Code Review

2018 Changes to International Codes

IRC - FIRE SAFETY - FIRE TAC

**2018 International Residential Code – Fire safety
Fire TAC**

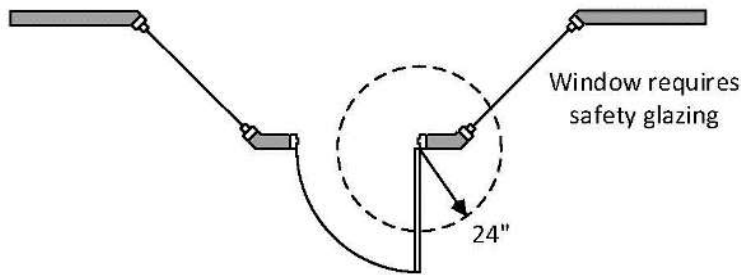
Commenter's Reason: This public comment clarifies when safety glazing is required for an in-swinging door. The original requirement was introduced into the 2015 IRC through code change proposal RB111-13. Based on the figures included in the reason statement (one of which is reproduced below) and the discussions on the proposal, our understanding is the concern being addressed by this provision is that a person can get pinned between the door and the wall, forcing the person against the glazing. The requirement safety glazing in this particular provision is not to address trip/fall/slip hazards, else it wouldn't only be required on the hinge side of the in-swinging door as shown in the figure for RB111-13

However, this proposed change can be interpreted to apply to situations where there is no danger of pinning a person between the door and the window. The figure below illustrates a situation where the wall bends away from the hinge side of the door. In this case, the door swing will be limited by the hinges and the walls, and there is no hazard from the door, but given the text of this proposal only refers to "not in the plane" of the door, safety glazing would be required in the window as shown.

The proposed modification will clarify that only if the window is in a position where a person can get pushed against the window by a door, will safety glazing be required.

R308.4.2 Glazing adjacent to doors. Glazing in an individual fixed or operable panel adjacent to a door shall be considered to be a hazardous location where the bottom exposed edge of the glazing is less than 60 inches (1524 mm) above the floor or walking surface and it meets either of the following conditions:

1. Where the glazing is within 24 inches (610 mm) of either side of the door in the plane of the door in a closed position.
2. Where the glazing is on a wall ~~not in~~ less than 180 degrees from the plane of the door in a closed position and within 24 inches (610 mm) of the hinge side of an in-swinging door.

**FIGURE R308.4.7
PROHIBITED HAZARDOUS GLAZING LOCATIONS AT BOTTOM STAIR LANDINGS**

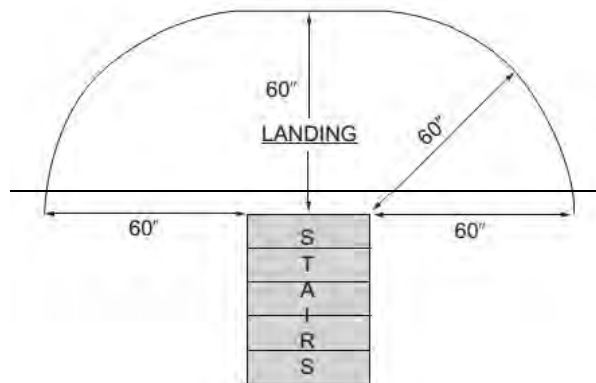
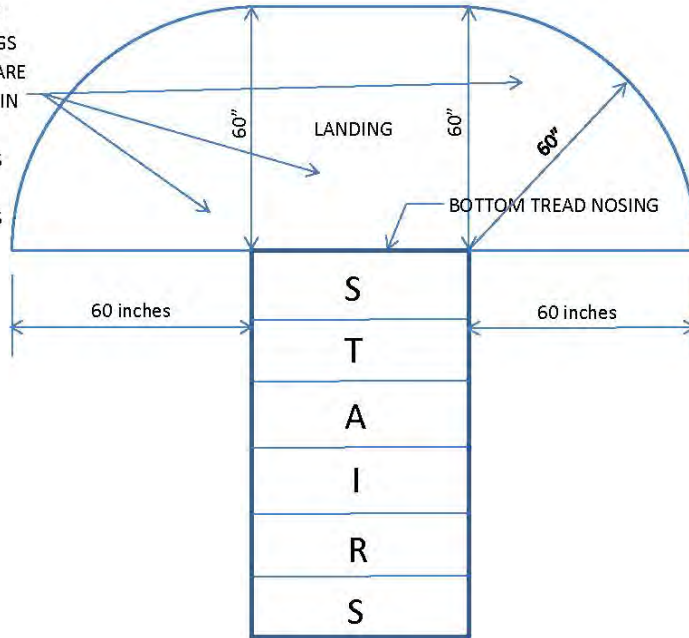
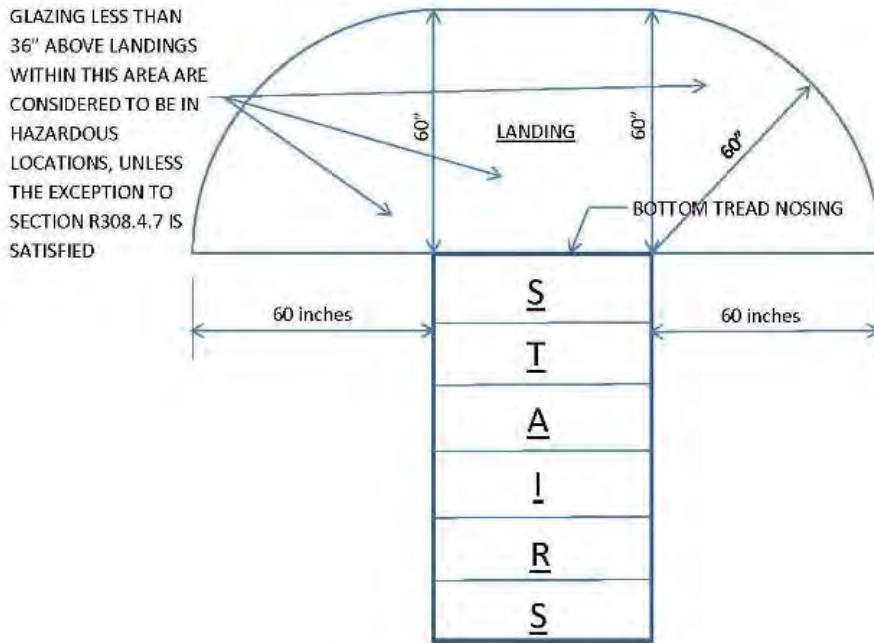
RB82-16	R308.4.7	<p>Modified Figure R308.4.7 “HAZARDOUS GLAZING LOCATIONS AT BOTTOM STAIR LANDINGS”. This proposal is intended to provide information on the figure with two callouts that describe the meaning of the figure, consistent with the text of Section R308.4.7. In addition, as figure titles are not enforceable, an editorial change is proposed to the title of the figure to more accurately reflect the meaning. This proposal cleans up the code and makes it more understandable. By labeling the stairs and landing, the modification further clarifies the intent of the code.</p> <p>Cost Impact: Will not increase the cost of construction.</p>	Same as change between 2015 IRC-B and 2018 IRC-B		
---------	----------	--	--	--	--

Reason: This proposal is intended to provide information on the figure with two callouts that describe the meaning of the figure, consistent with the text of Section R308.4.7. In addition, as figure titles are not enforceable, an editorial change is proposed to the title of the figure to more accurately reflect the meaning. Lastly, we have adjusted the 60 inch dimension at the landing for clarity. This proposal is submitted by the ICC Building Code Action Committee (BCAC). BCAC was established by the ICC Board of Directors to pursue opportunities to improve and enhance assigned International Codes or portions thereof. In 2014 and 2015 the BCAC has held 5 open meetings. In addition, there were numerous Working Group meetings and conference calls for the current code development cycle, which included members of the committee as well as any interested party to discuss and debate the proposed changes. Related documentation and reports are posted on the BCAC website at: [BCAC](#)

GLAZING LESS THAN 36" ABOVE LANDINGS WITHIN THIS AREA ARE CONSIDERED TO BE IN HAZARDOUS LOCATIONS, UNLESS THE EXCEPTION TO SECTION R308.4.7 IS SATISFIED

Fig. A

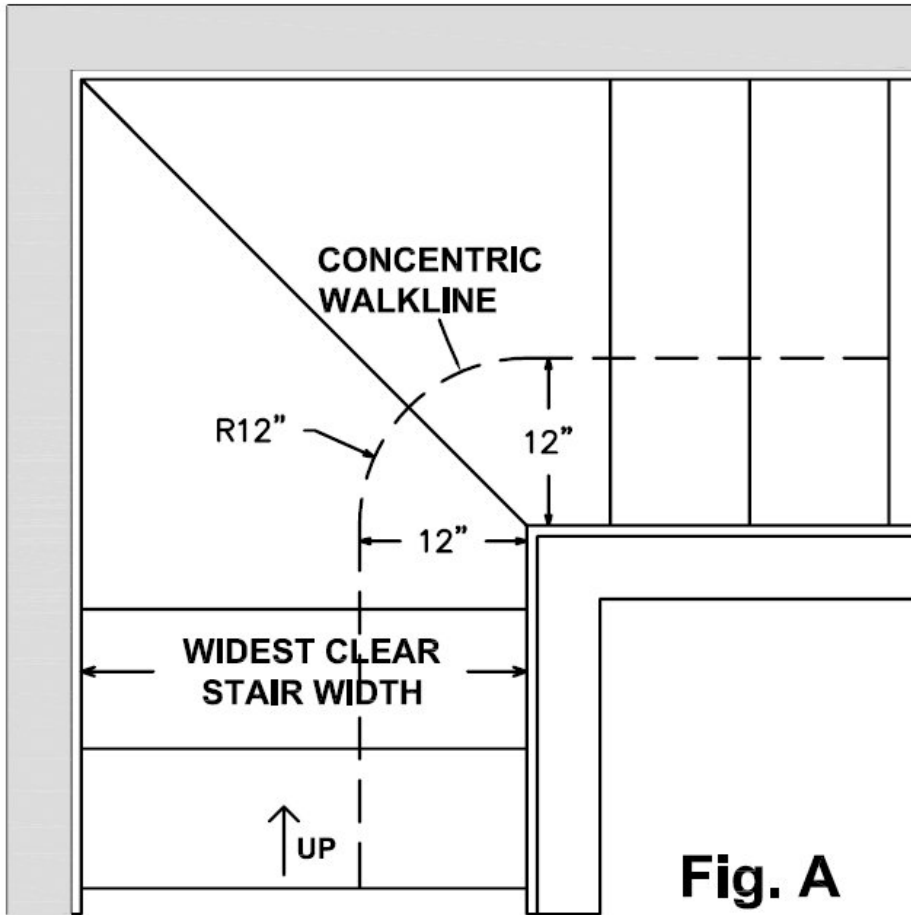
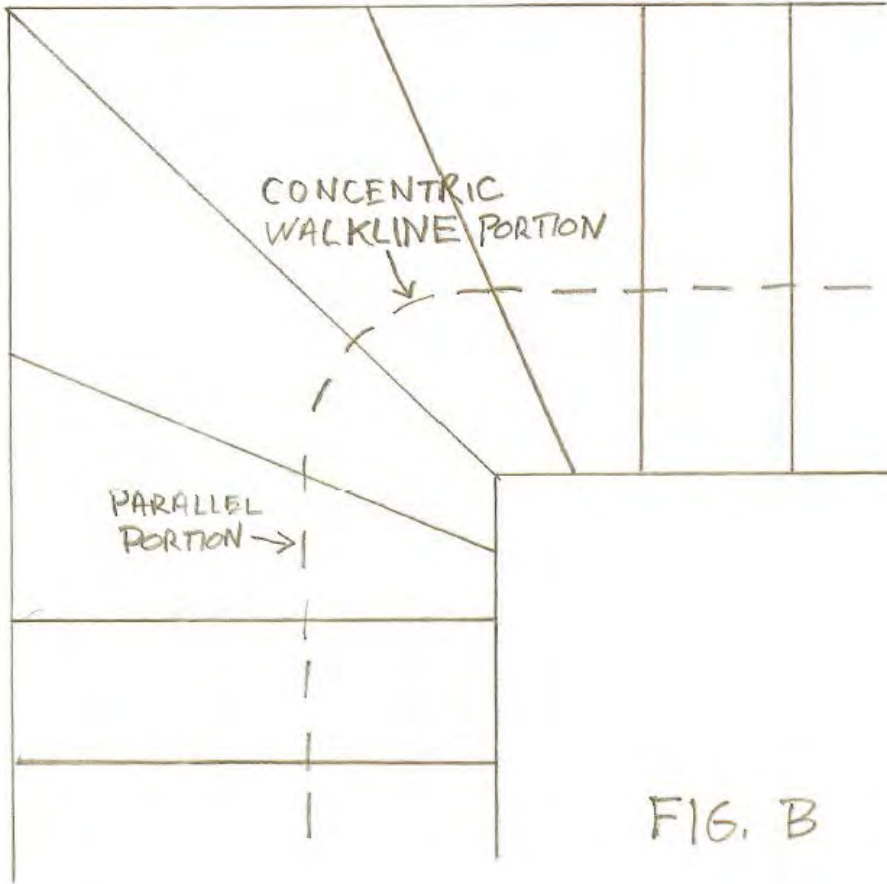
Landings have been added because **R311.7.6 Landings for stairways** regulates landing "depth at the walkline" however **R311.7.4 Walkline** only references winders.

"Inside of the turn" is suggested to replace "from the side where the winders are narrower" as it also applies to the the walkline at the landing where there are no winders. Finally the substitution of "Where" for "If" and "a" for "the" are intended to be better code language.
